ALEXANDER BOULEVARD ROADWAY IMPROVEMENTS GRIEGOS ROAD TO CARMONY LANE

RECORD DRAWING MARCH 87

CITY OF ALBUQUERQUE
PUBLIC WORKS DEPARTMENT
ENGINEERING DESIGN (TRANSPORTATION)
TITLE: ALEXANDER BOULEVARD
GENERAL NOTES, TYPICAL SECTION
AND MISCELLANEOUS DETAILS

**TITLE: PAVING PLAN & PROFILE
 ALEXANDER BOULEVARD
 STATION 13+00 TO STATION 15+00**

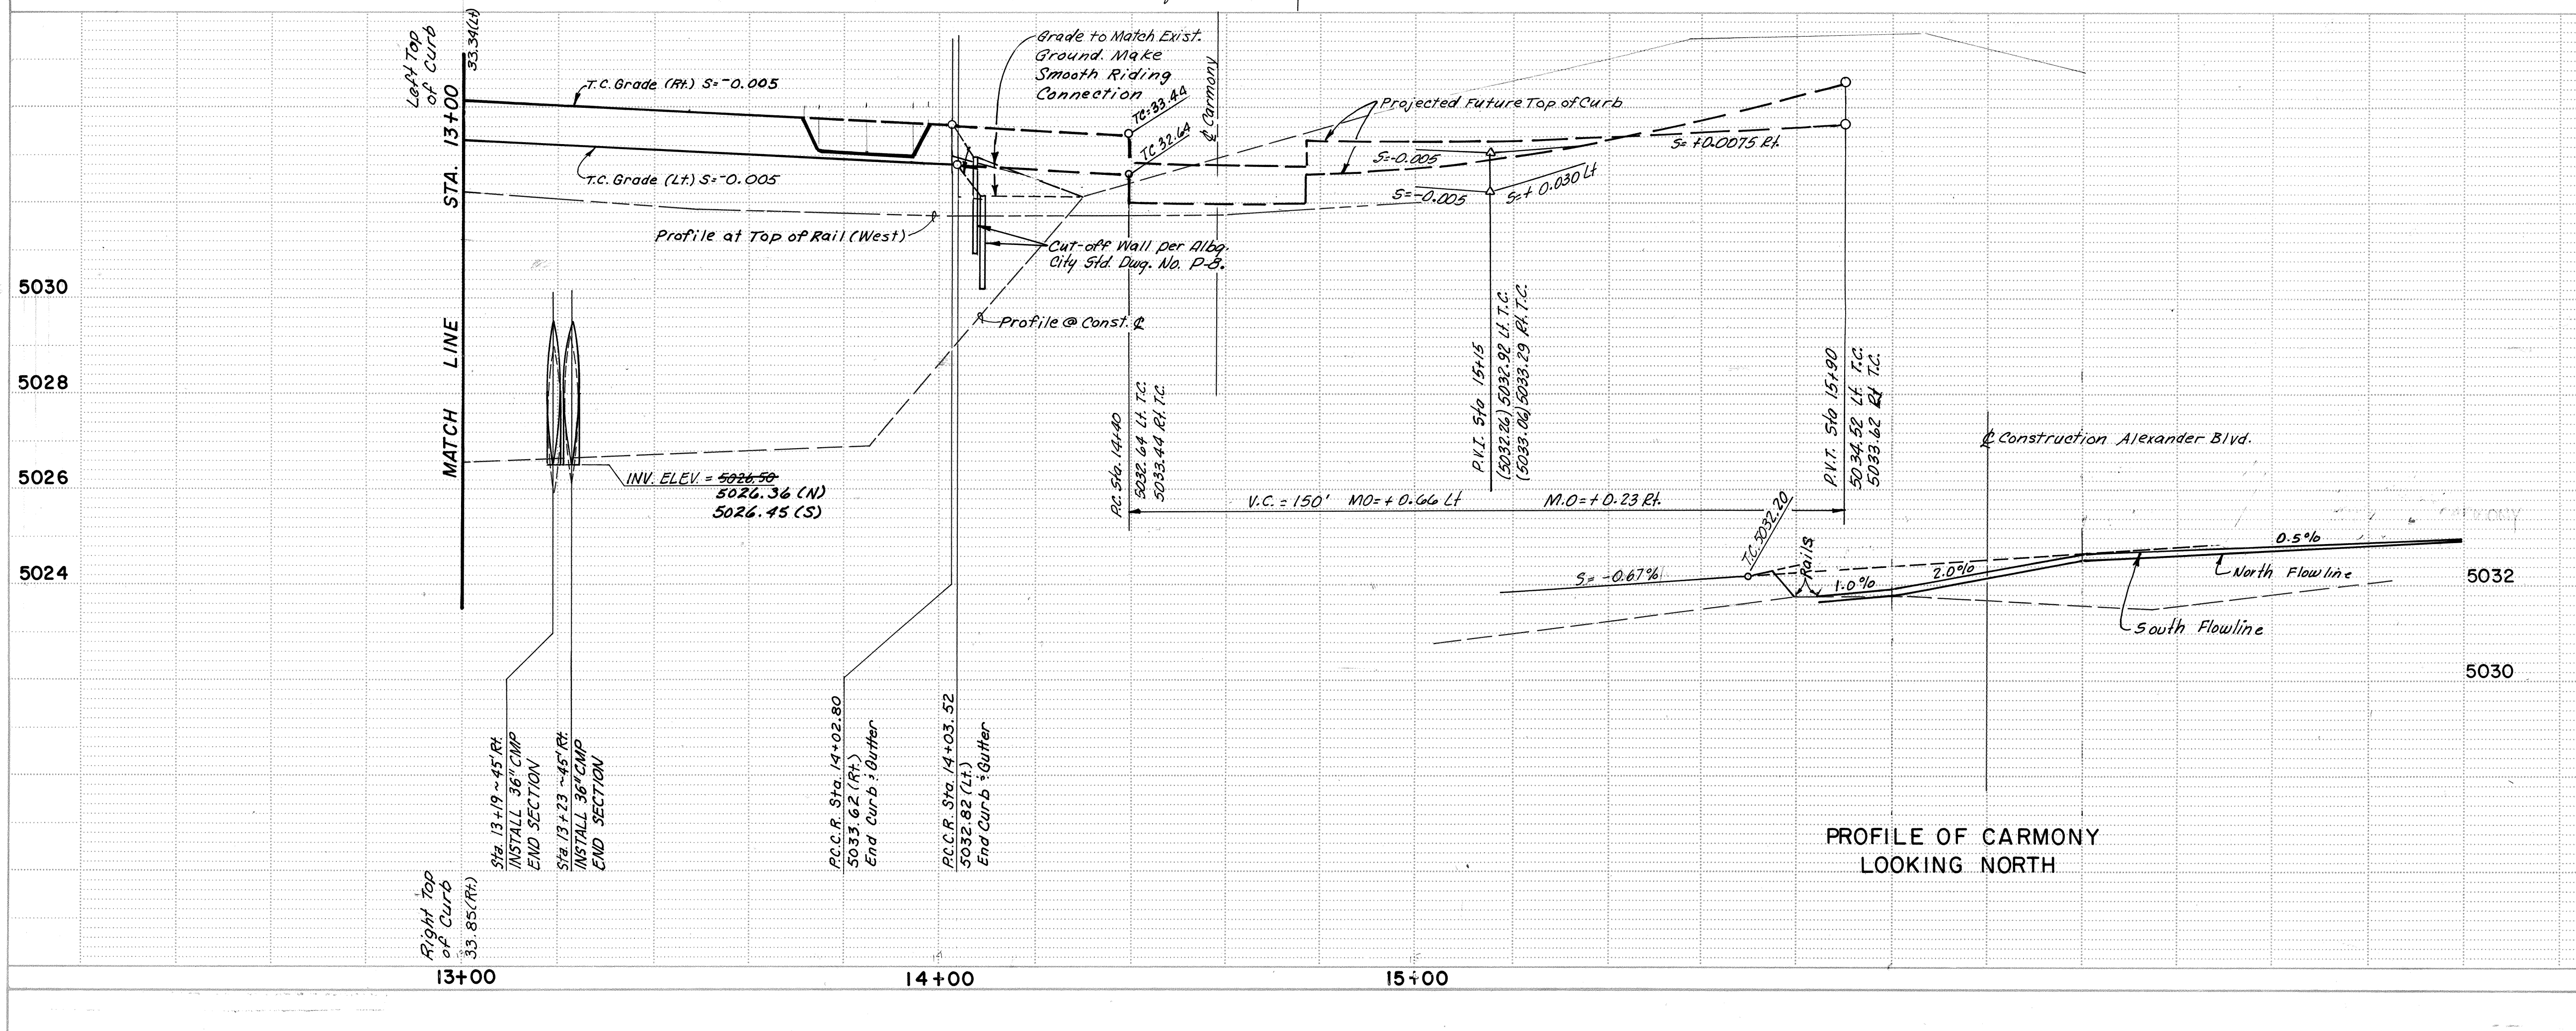
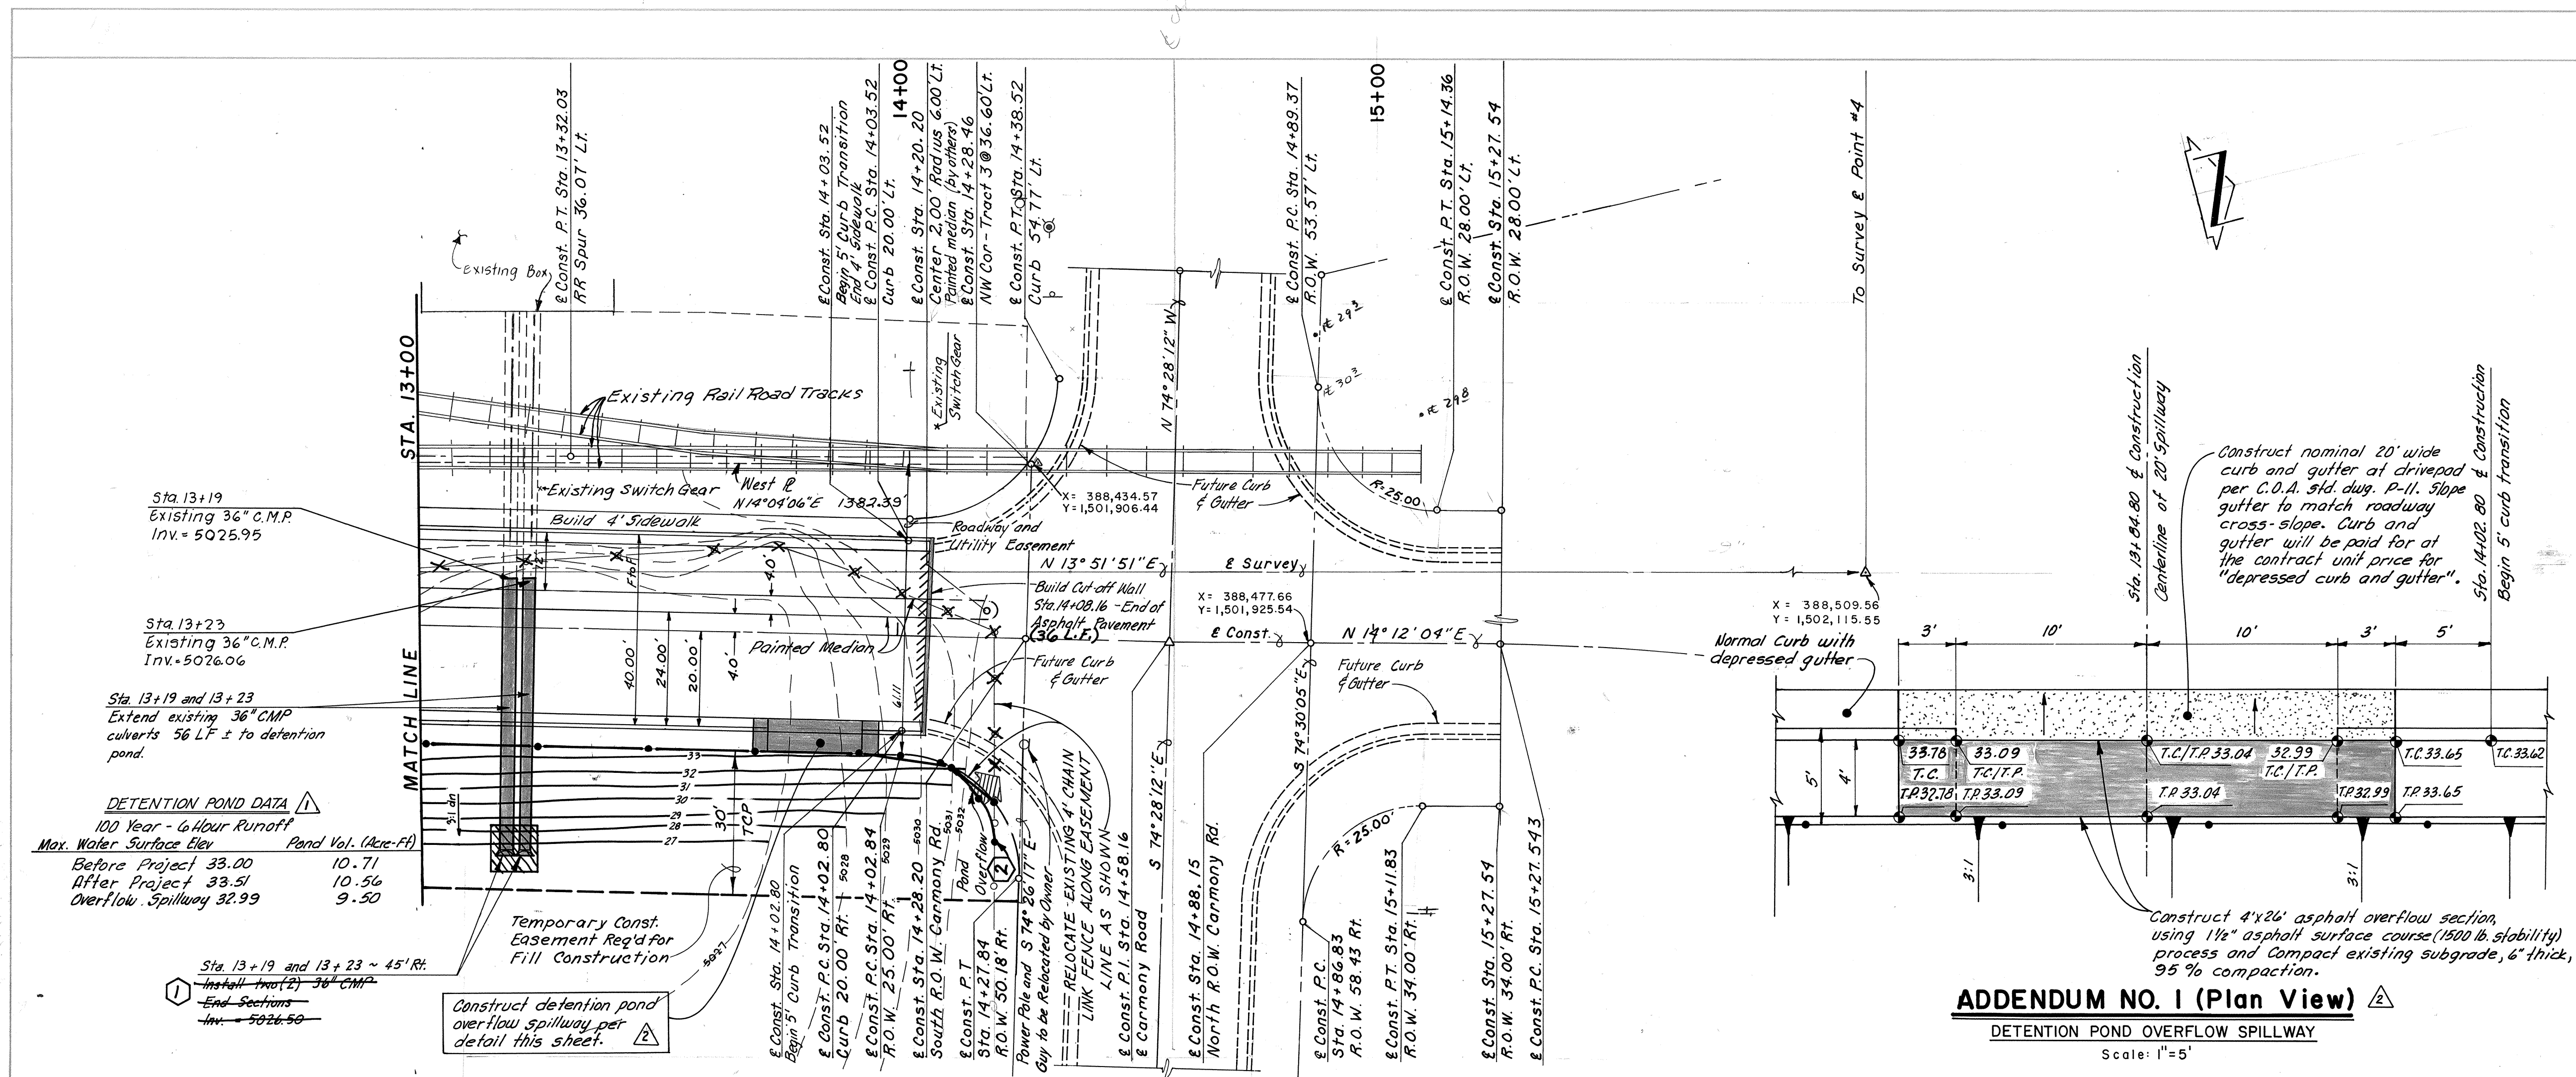
- Install 13'x12'x8" Thick Wire-Tied Rip-Rap End Treatment-Field Change #5
- End Relocation
